**City of Fairhope
Planning Commission Agenda
5:00 PM
Council Chambers
May 6, 2024**

A. SD 24.07 Public hearing to consider the request of the Applicant, Goodwyn Mills Cawood, LLC, on behalf of the Owner, Retirement Systems of Alabama, for Final Plat Approval of Battles Trace Phase 8, a 48-lot Major Subdivision. The property is approximately 28.53 acres and is zoned TR – Tourist Resort District. The property is located on the north side of Battles Road, on the east and west sides of Colony Drive. **PPINS #: 29244, 372296**

SD 24.07 - Battles Trace Phase 8

SD 24.12 - Hill Top Lot 29

**HARVEST GREEN WEST
PHASE ONE**
A PLANNED UNIT DEVELOPMENT

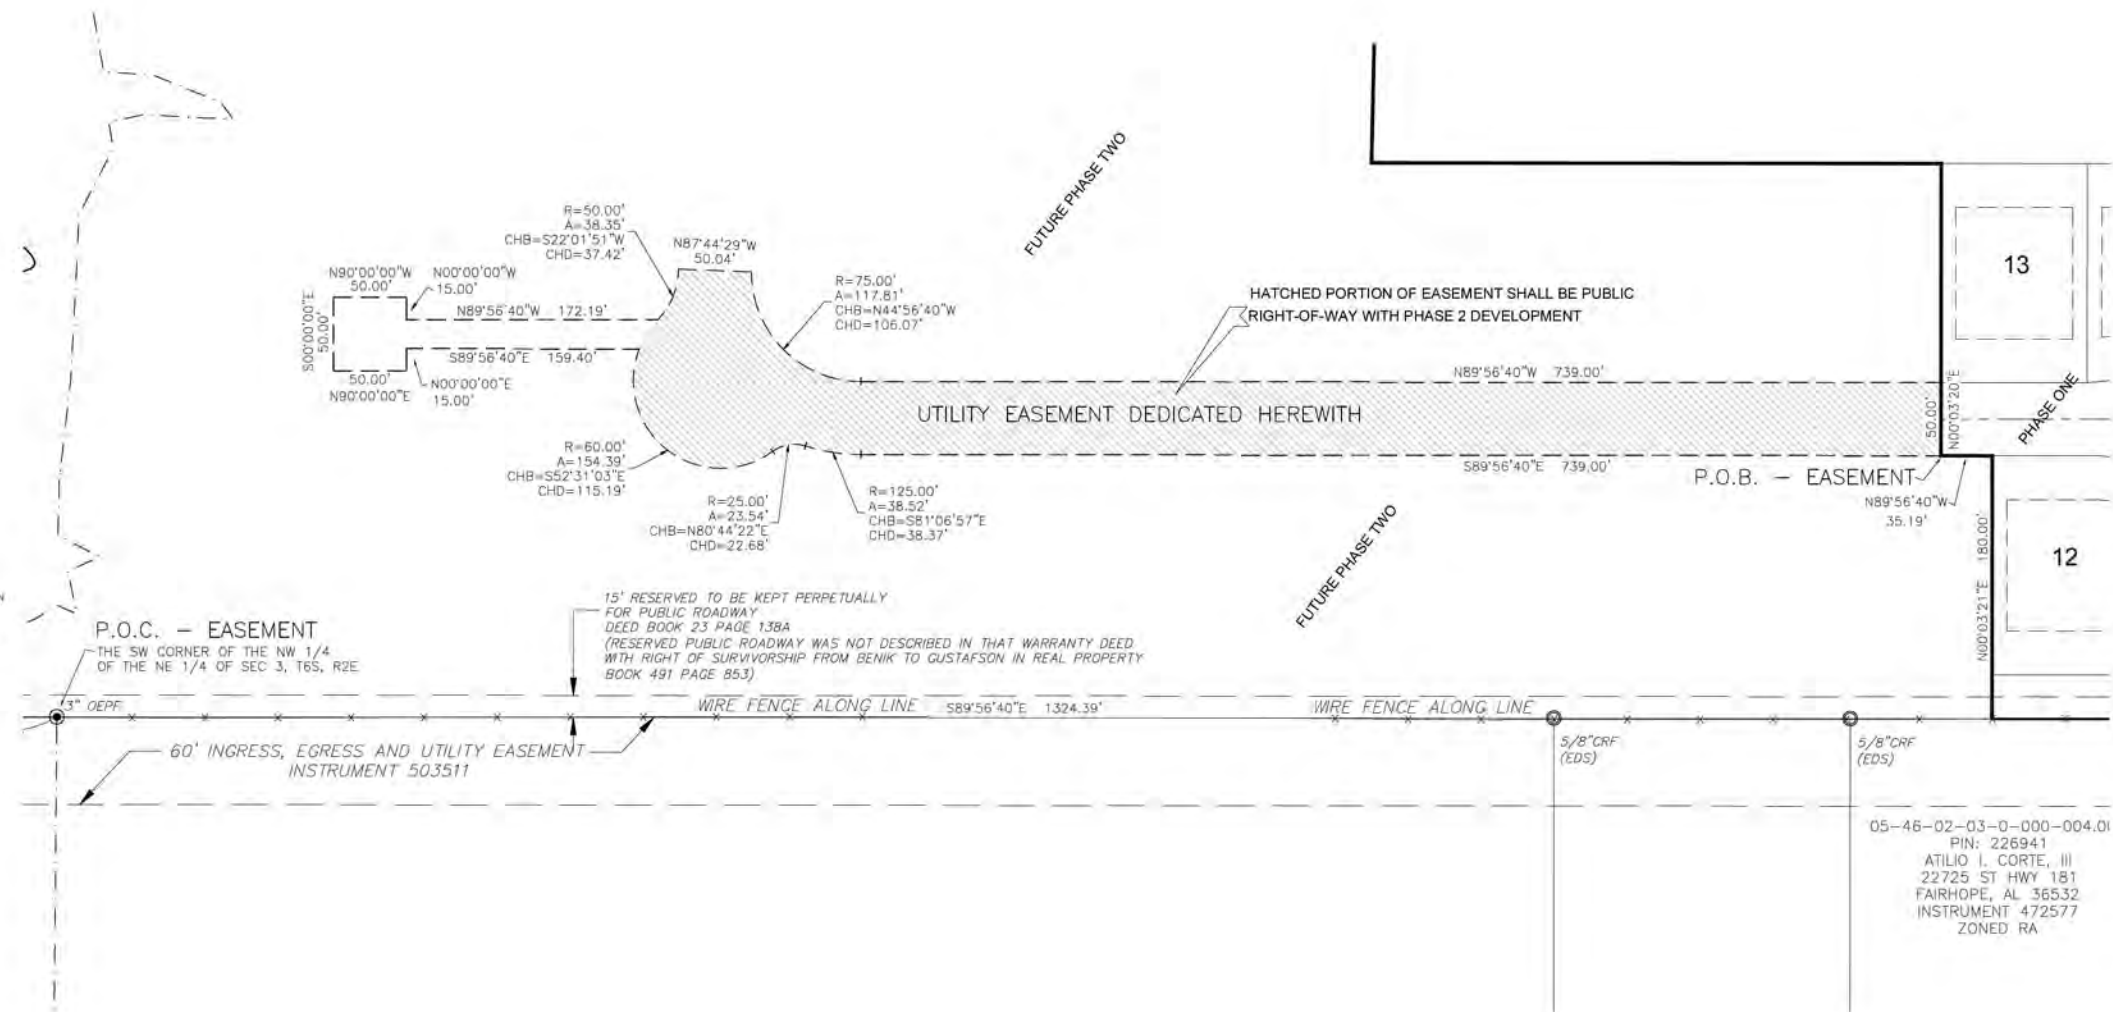
The lift station for this development is located in the future Harvest Green West Phase 2. A utility easement is provided for access. Once Phase 2 is complete the easement will be absorbed into the ROW. A Performance Bond is required for an access road to the lift station in the event that the future phase is not completed to ensure the Sewer Department has access to the lift station per City of Fairhope Water and Sewer Specs. The area around the lift station shall be a numbered lot to be deeded to the City of Fairhope and the plat revised accordingly.

1. Completion of Follow-Up Activities
2. Add the FFE for each lot.
3. Revise the plat to reflect the lift station as a numbered lot to be deeded to the City of Fairhope.
4. Provide correspondence from ALDOT confirming turnouts are permitted for public use.

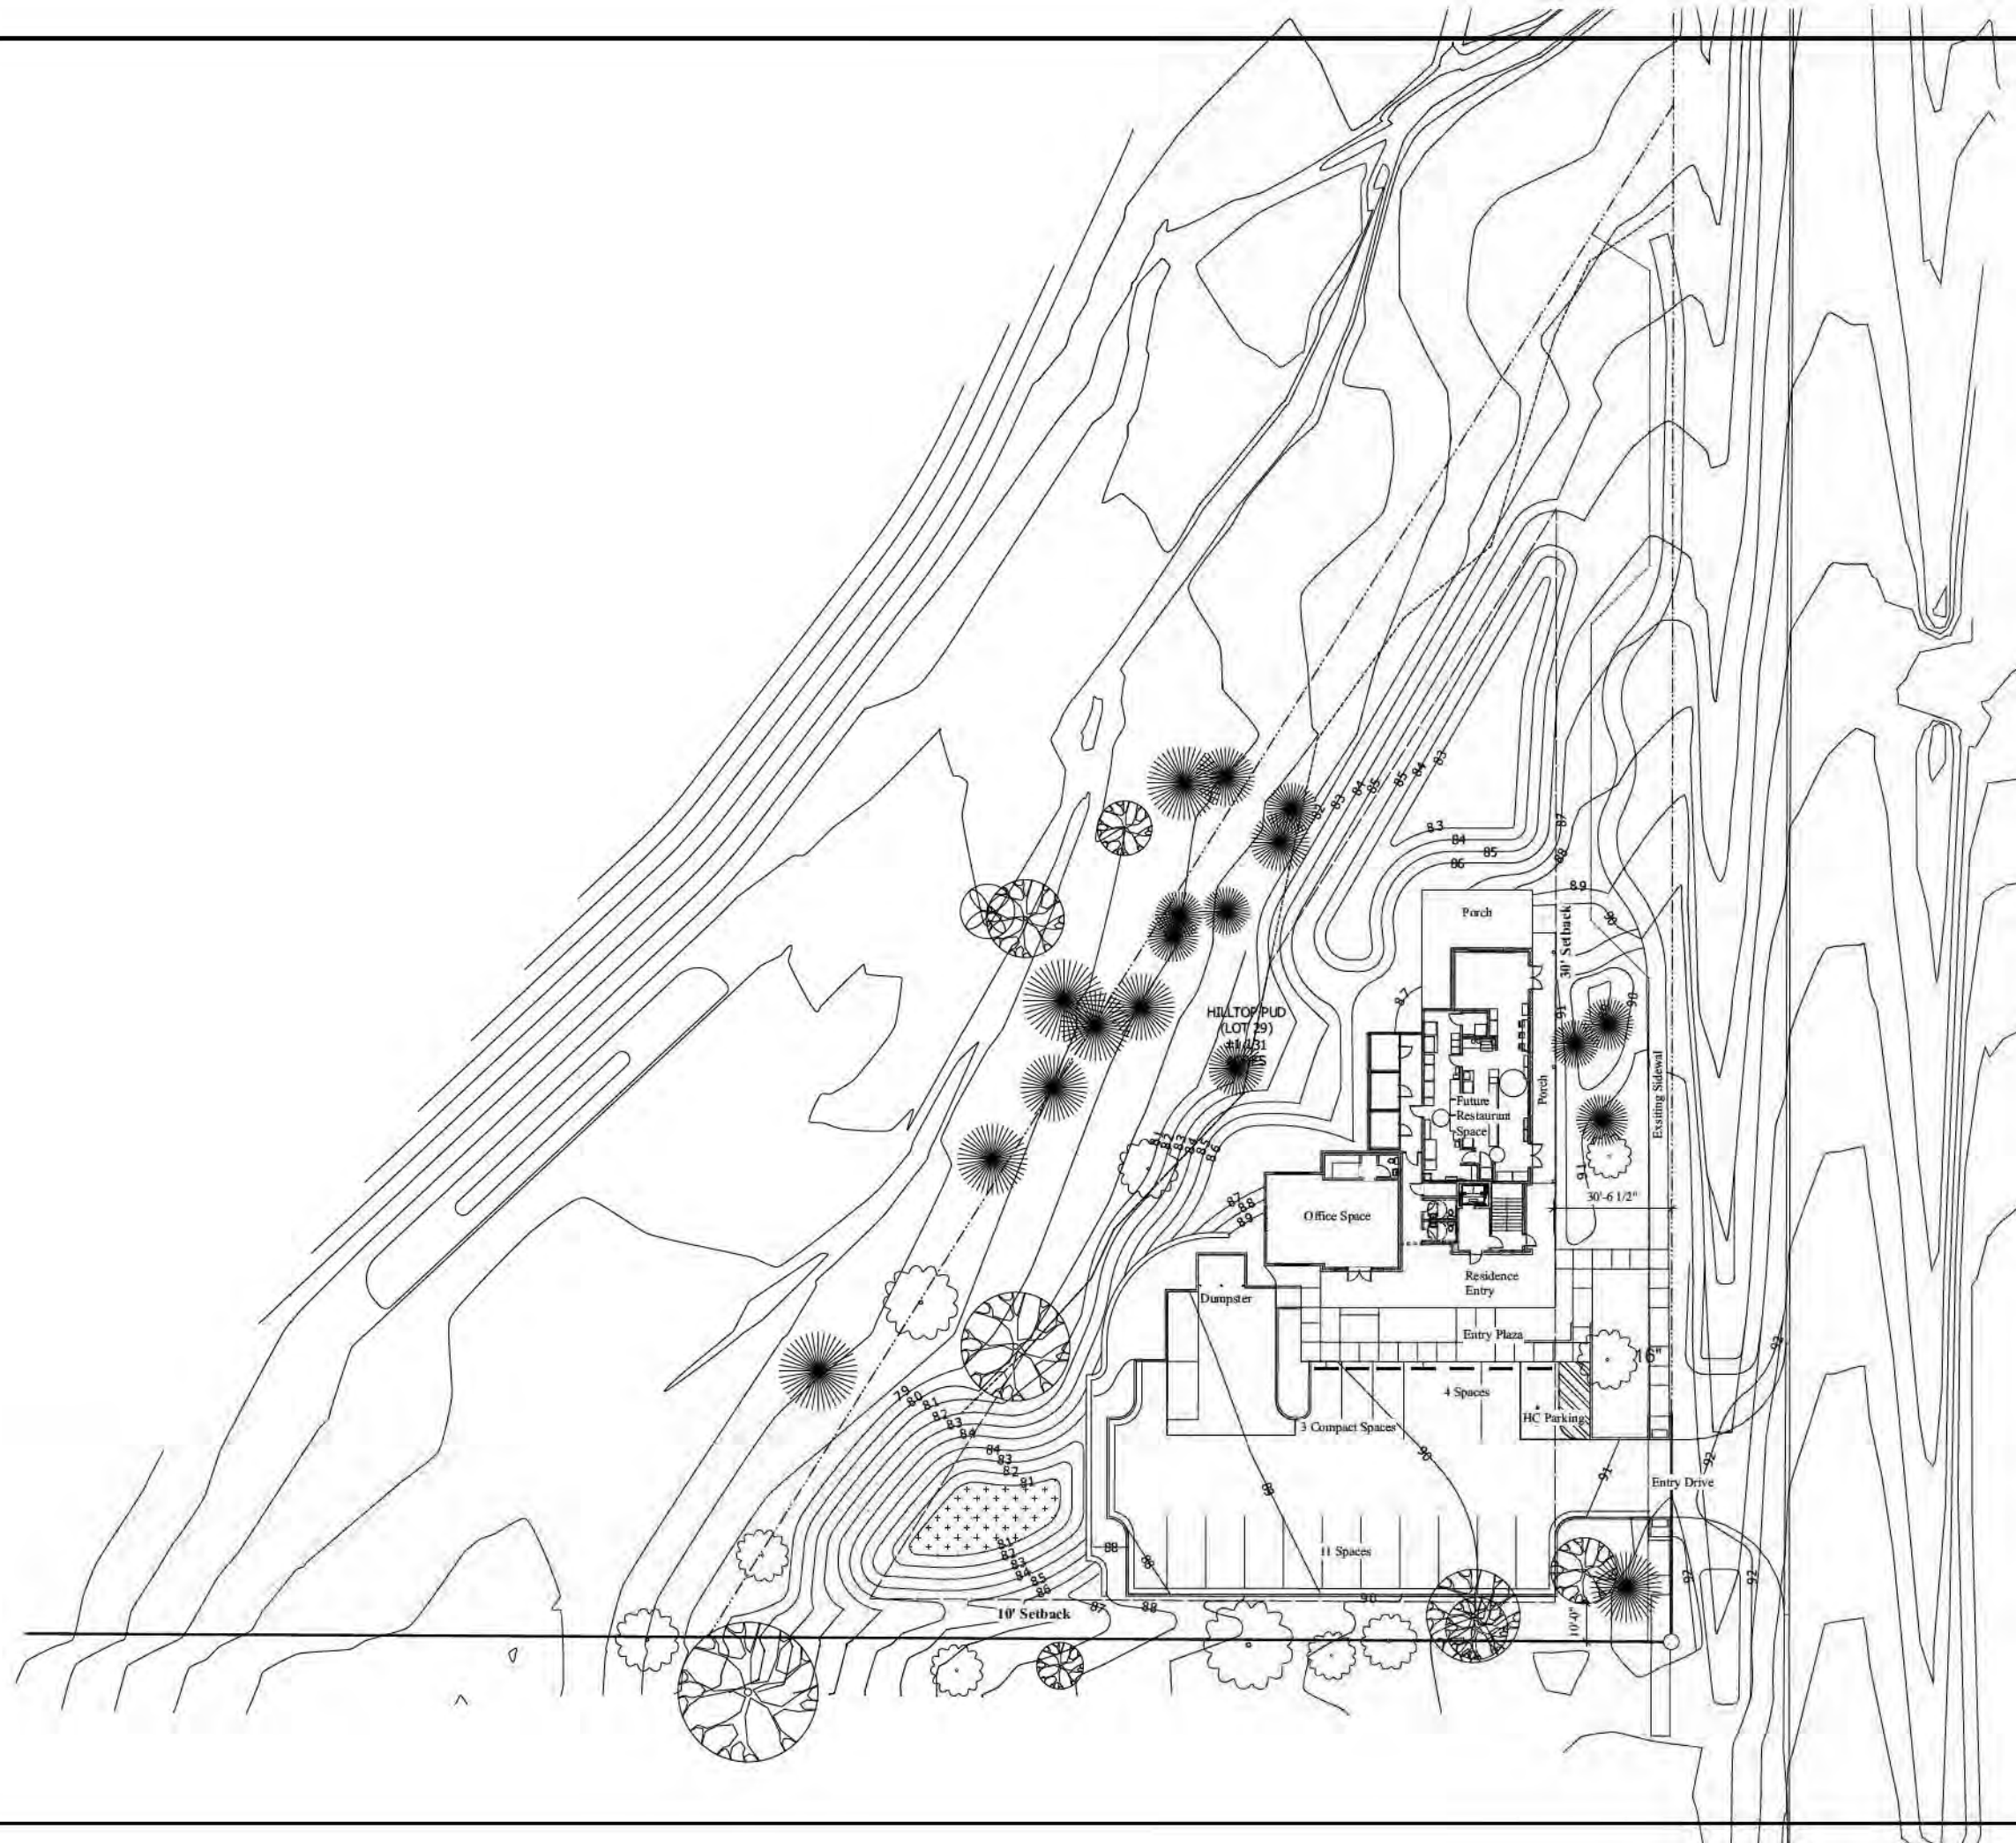
3. Please add "Lot 29" somewhere on the Greenspace Area Exhibit.

Response: *Enclosed is an updated Greenspace Area Exhibit. Bottom right corner and Site Data Table have been updated to reference "Hill Top Lot 29"*

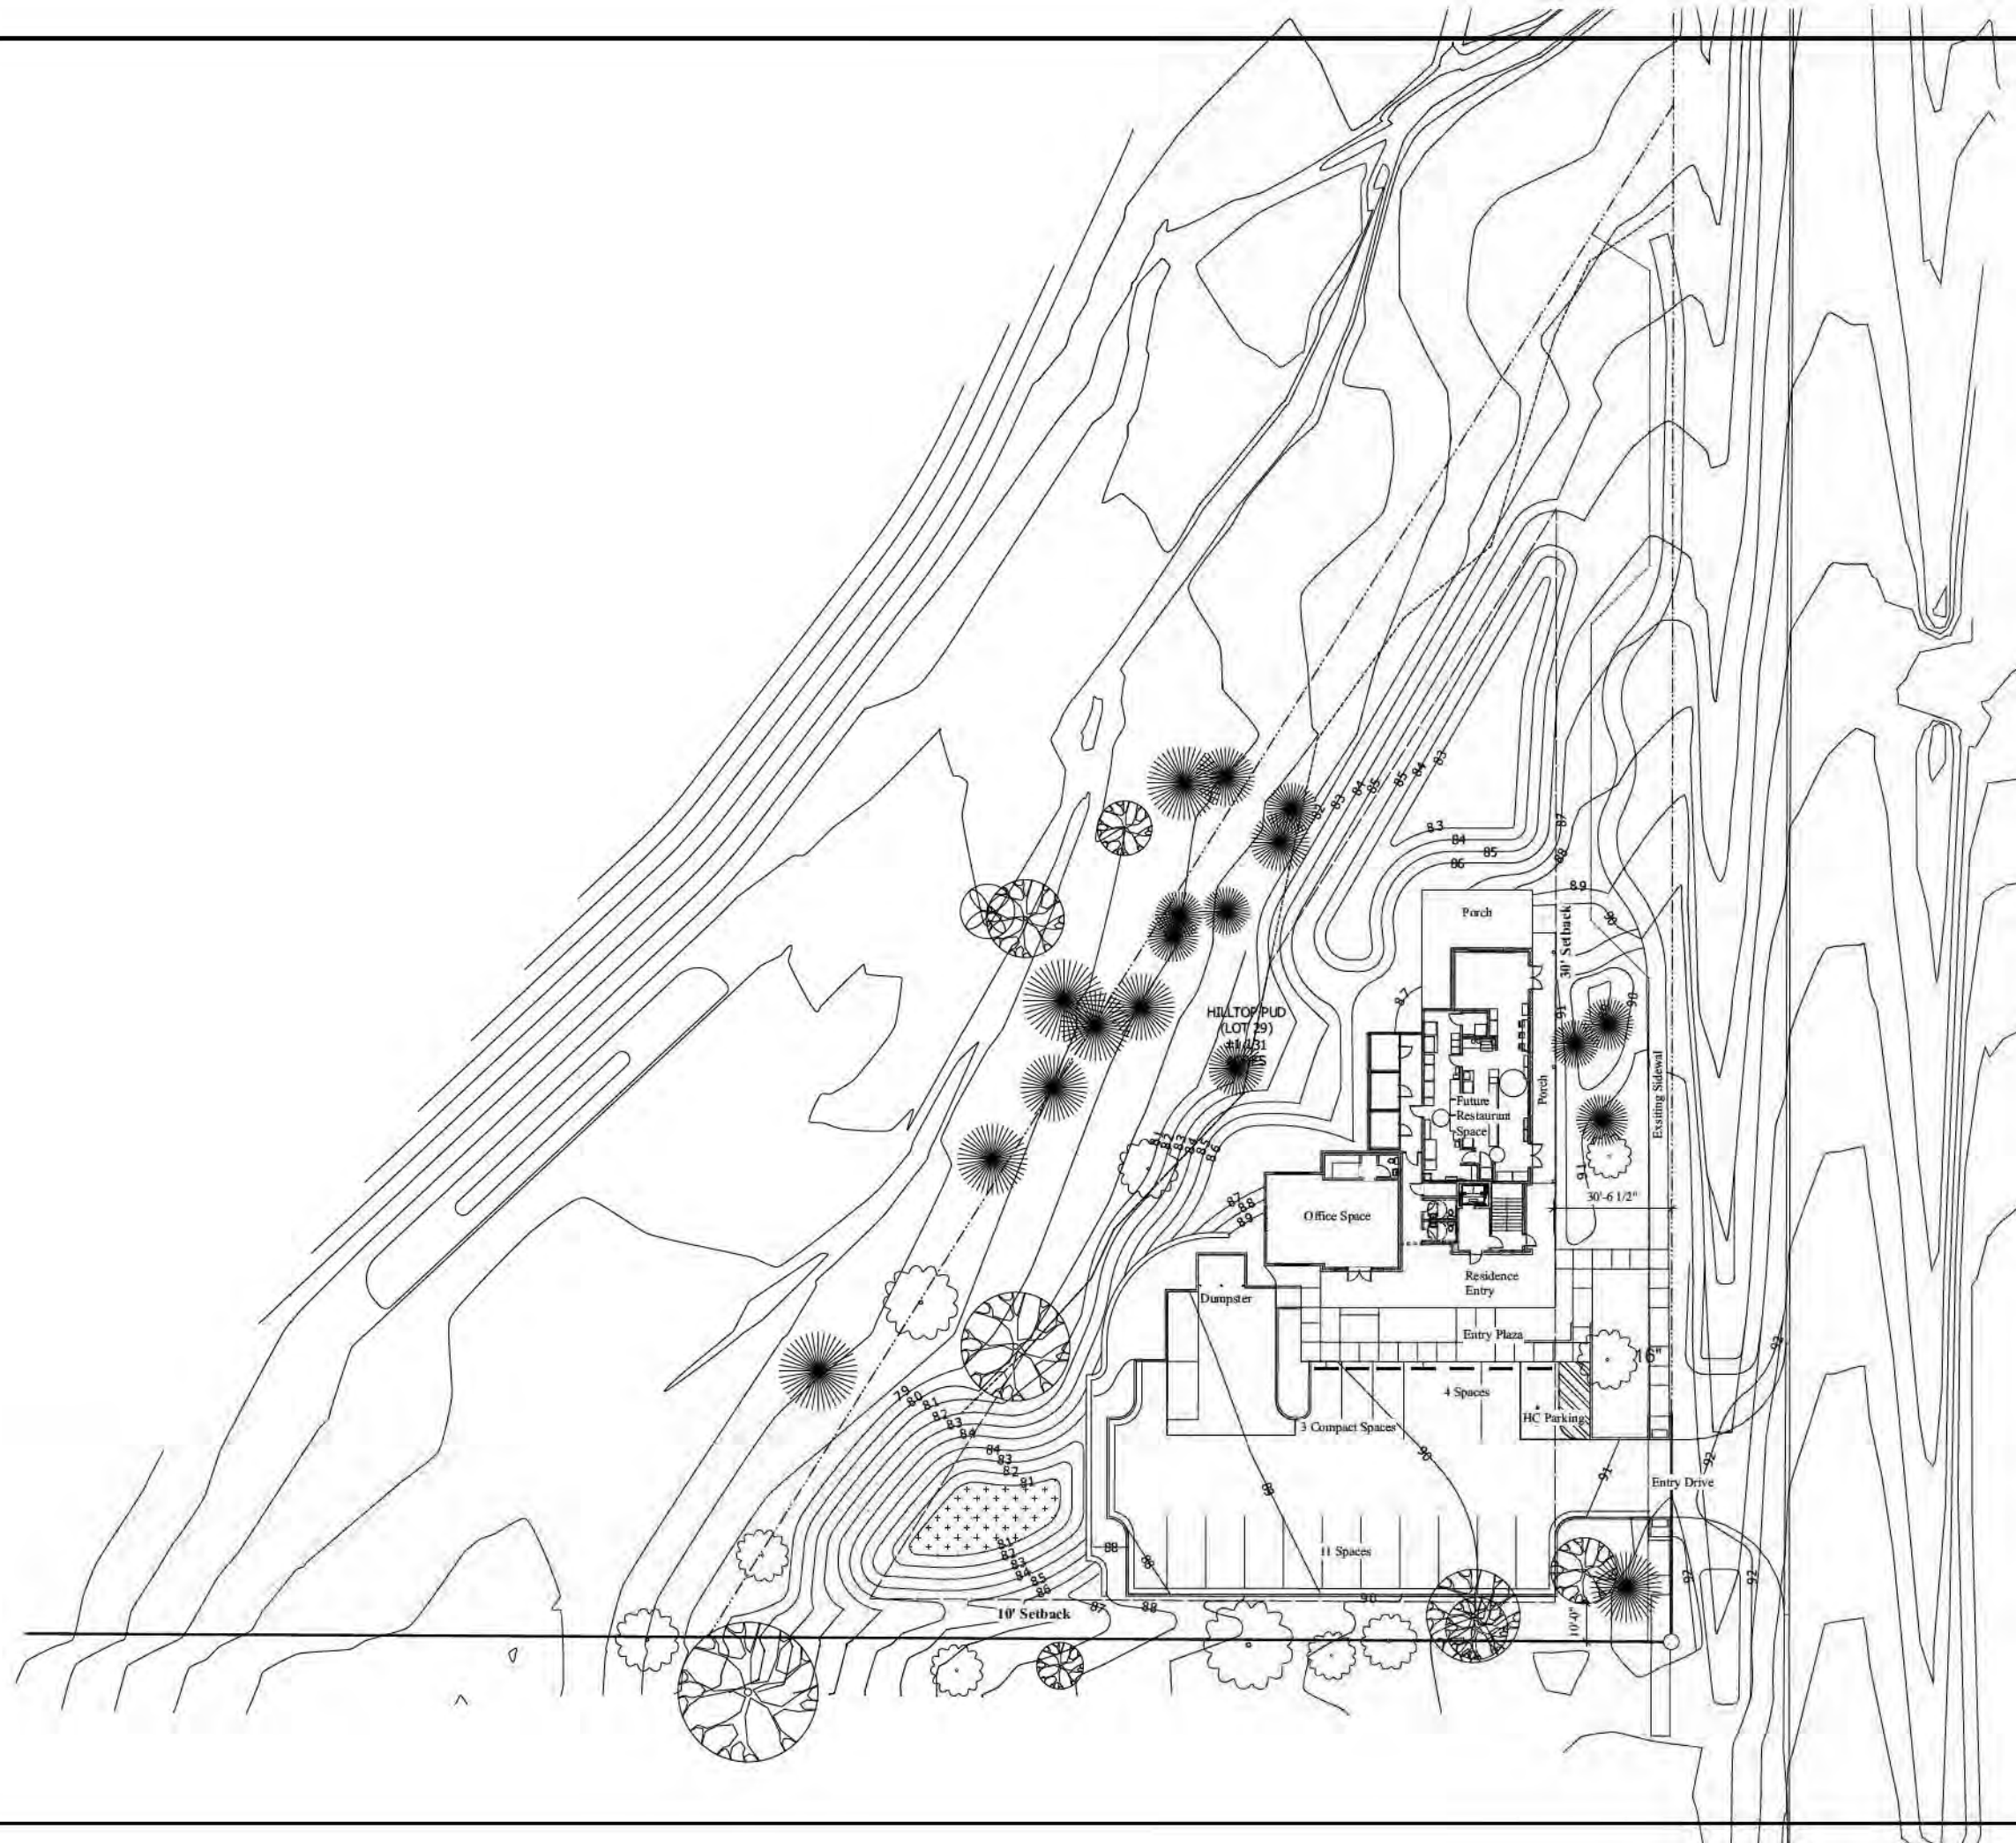
3. Please add "Lot 29" somewhere on the Greenspace Area Exhibit.

Response: *Enclosed is an updated Greenspace Area Exhibit. Bottom right corner and Site Data Table have been updated to reference "Hill Top Lot 29"*
